# Stage 05: Draft Final Modification Report

## GC0099:

**Modification Title: Establishing a common approach to interconnector scheduling consistent with the single intraday market coupling processes set out within Regulation (EU) 2015/1222 (CACM).**

**Published on:** 18 April 2018

Figure 1

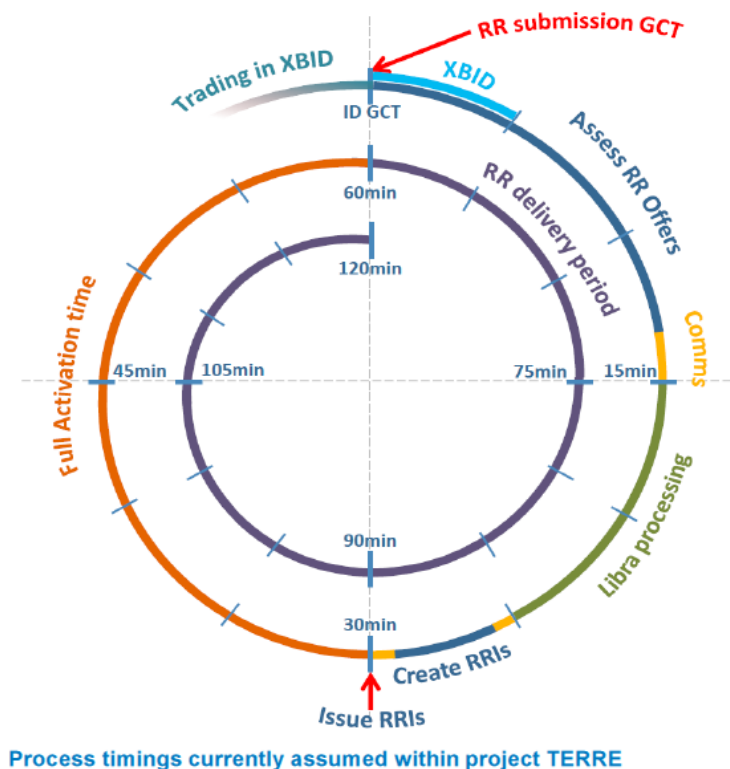
The spiral diagram in figure 1 was talked through; the timings for which reflect the current proposal for the ongoing Modification Project TERRE. The timings being proposed have not all been finalised, however the deadline for receipt of information by the central platform (15 mins after gate closure), full activation time (30 minutes) and the delivery period (60 minutes) have been long established<sup>1</sup> within the TERRE project and National Grid understands that changing these times would represent a significant risk to the successful delivery of the project.
